PROJECT: SES Solar One

RE: SES Solar One Project
Applicant's Responses to CURE Data Requests 276-380
CURE Data Requests Set 3

In Response to CURE Data Requests
Set 3, Data Requests 276-380

Application for Certification (08-AFC-13)

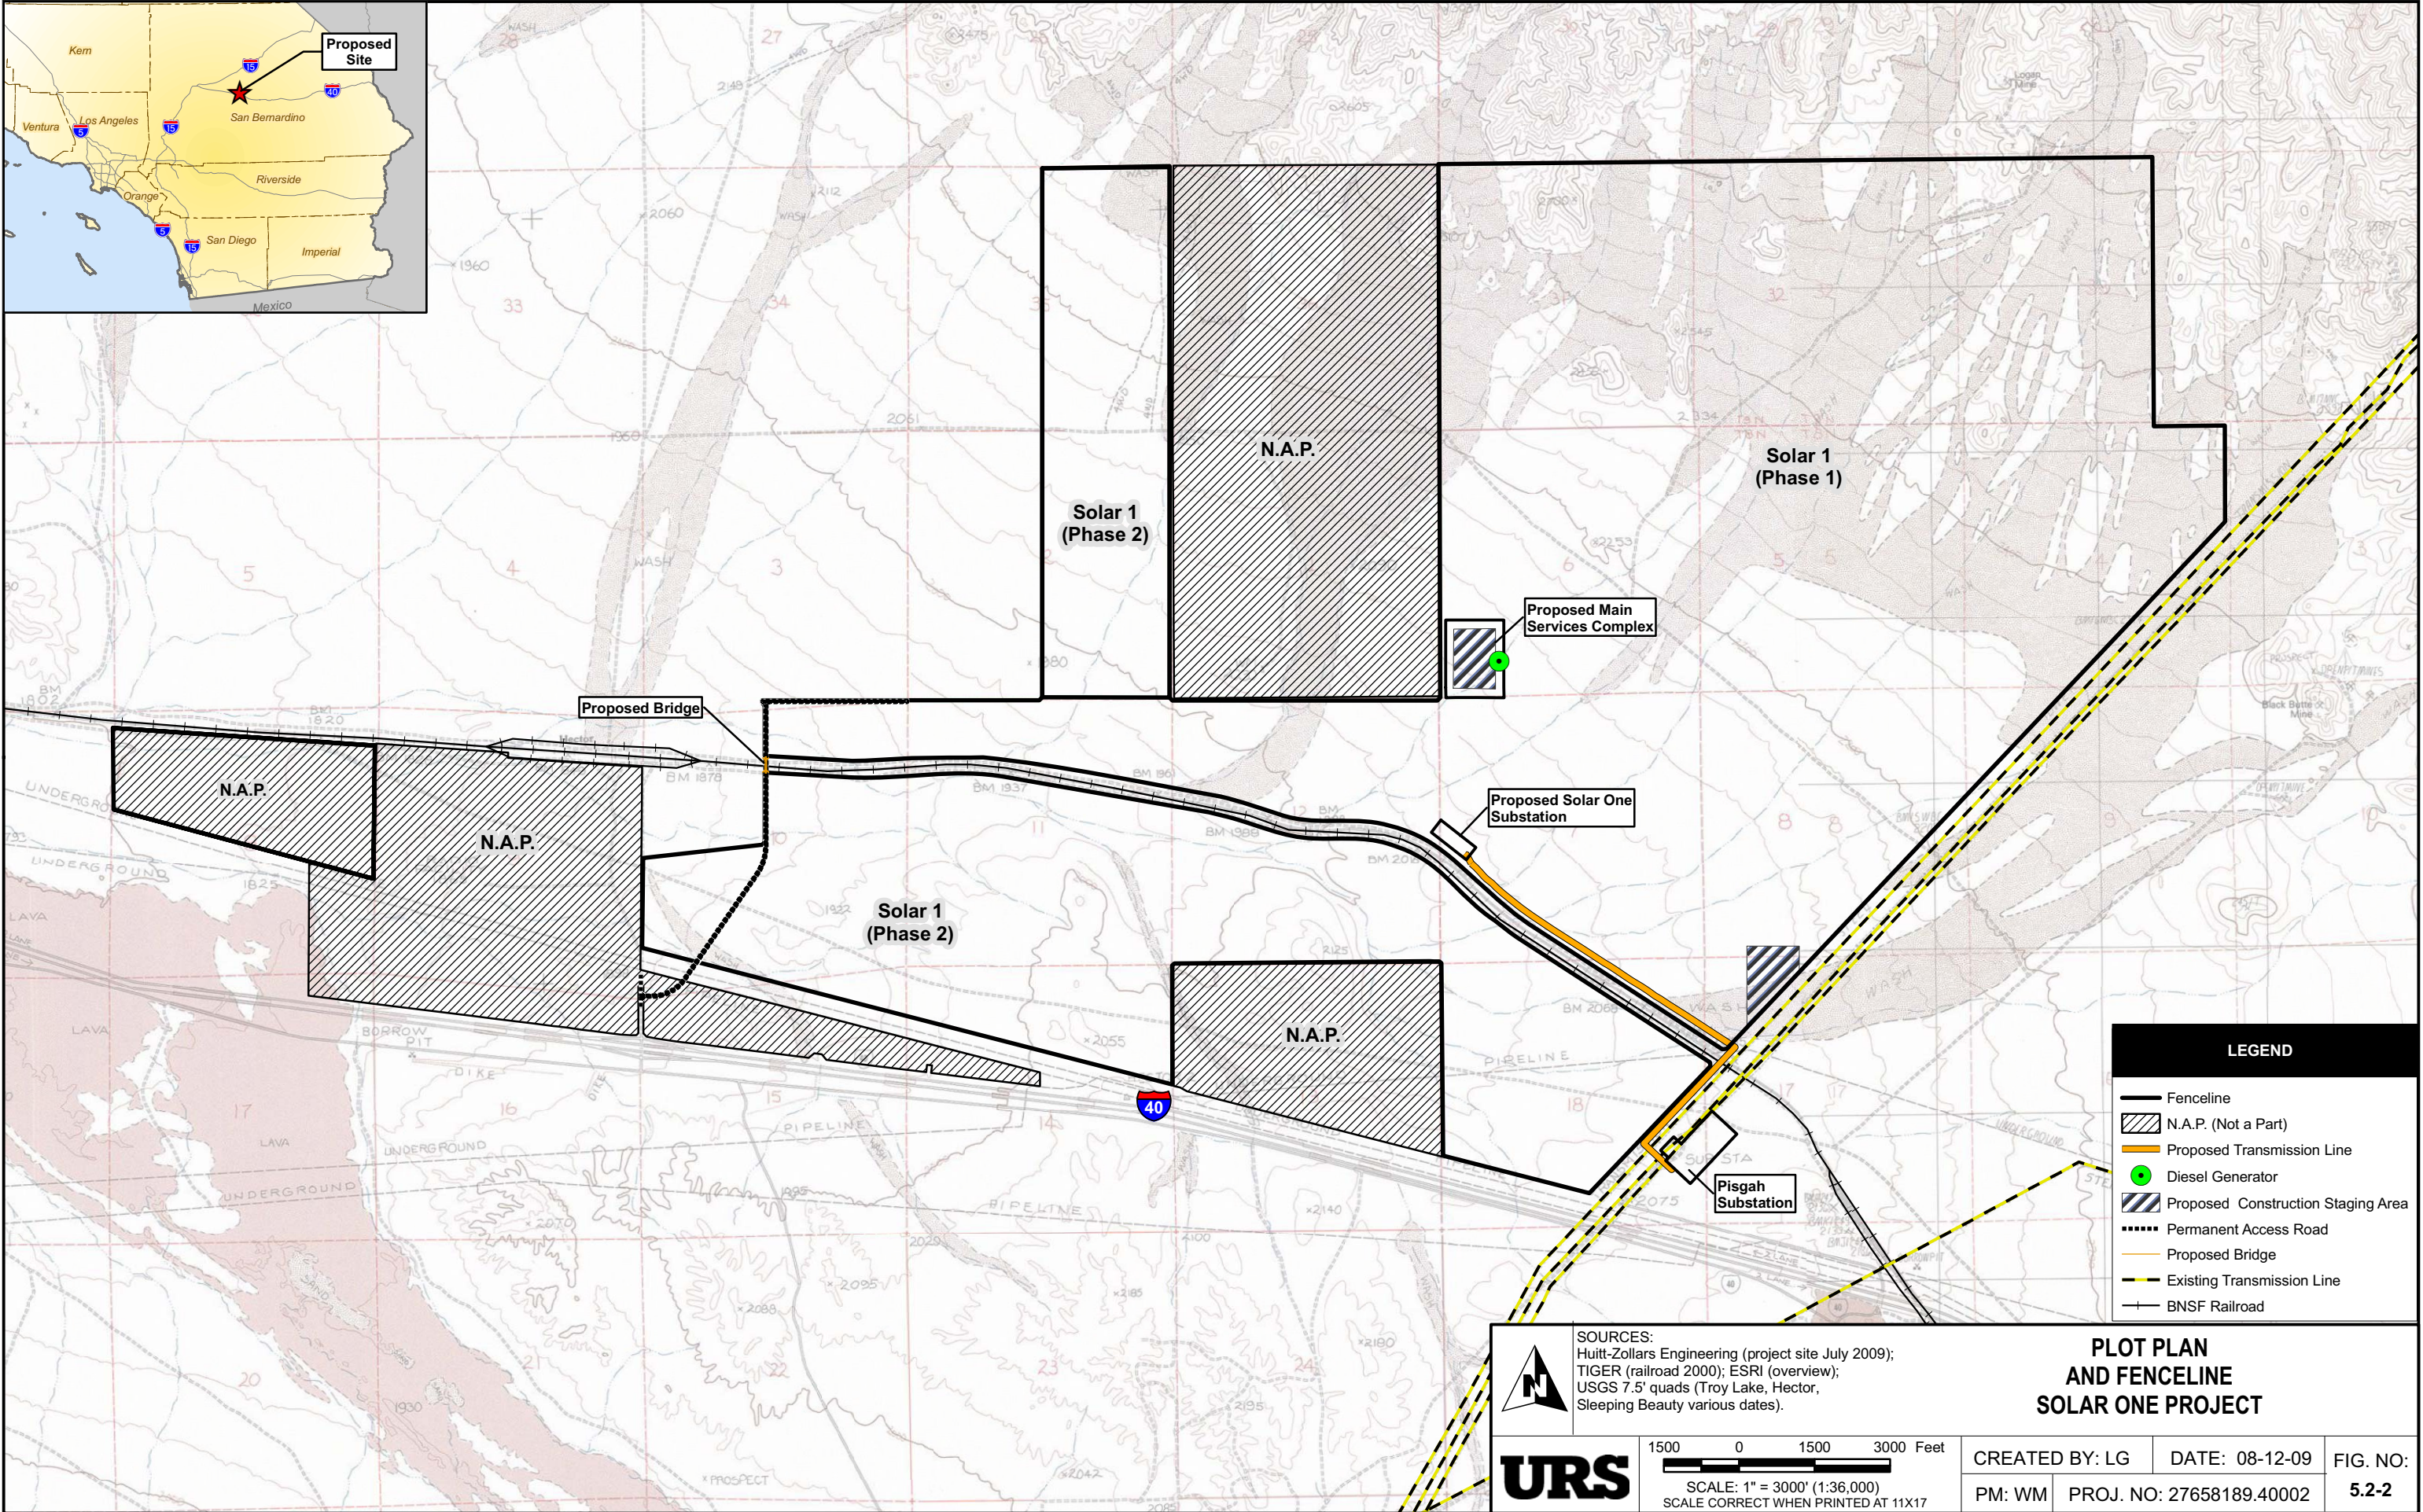
Data Request 342: Please discuss the cumulative impacts of the Project on white-margined beardtongue. In your response, please indicate the number of known occurrences of white-margined beardtongue that will remain if all projects proposed for the region are approved.

Response: Because the entire range of white-margined beardtongue has not been surveyed, it is impossible to determine the overall number that exists. We do not have data from other proposed projects in the region that show whether or not white-margined beardtongue occurs on those projects or not, and cannot practicably estimate the number of known occurrences of white-margined beardtongue that will remain if all the projects proposed for the region are approved, which in itself is highly unlikely.

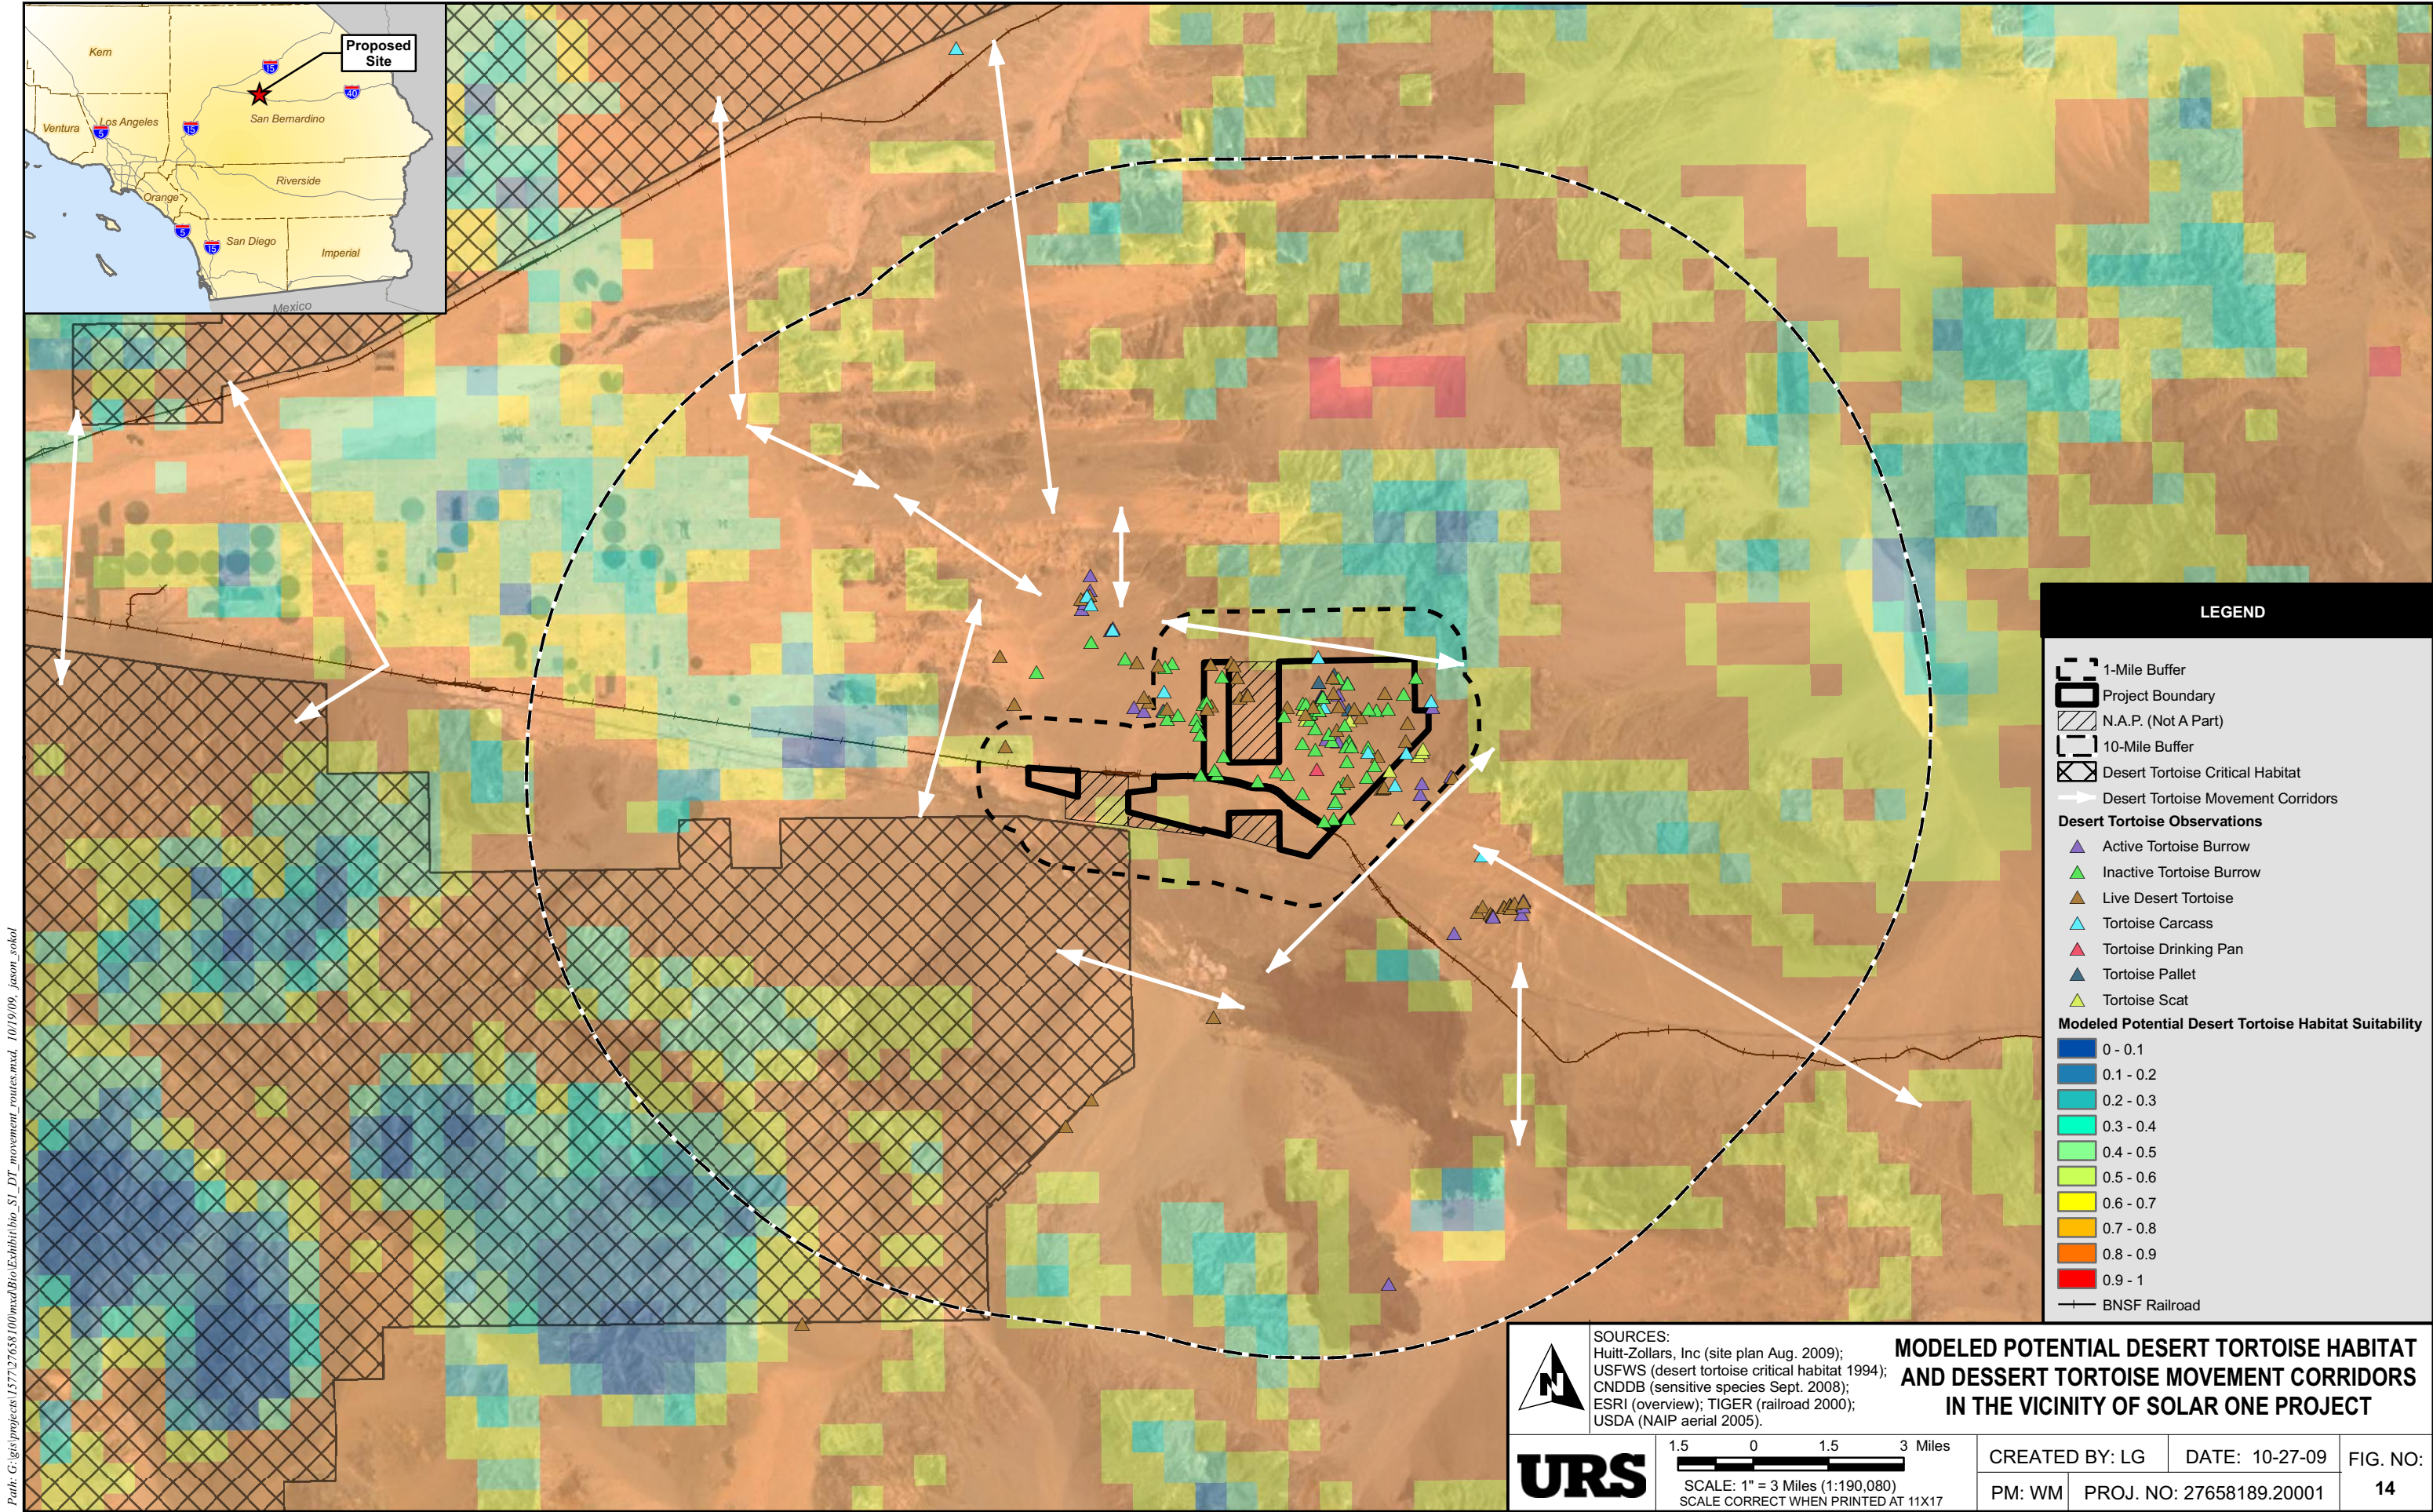
Data Request 352: Please provide a discussion of the analysis that was used to estimate Project impacts to wildlife corridors.

Response: A visual analysis based on modeled desert tortoise habitat was used to determine potential movement corridors, with the focus on maintaining movement between designated critical habitat areas. Two designated desert tortoise critical habitat areas exist, one to the northwest of the site and another to the southwest of the site. Implementation of the Project will not impede movement between these two areas.
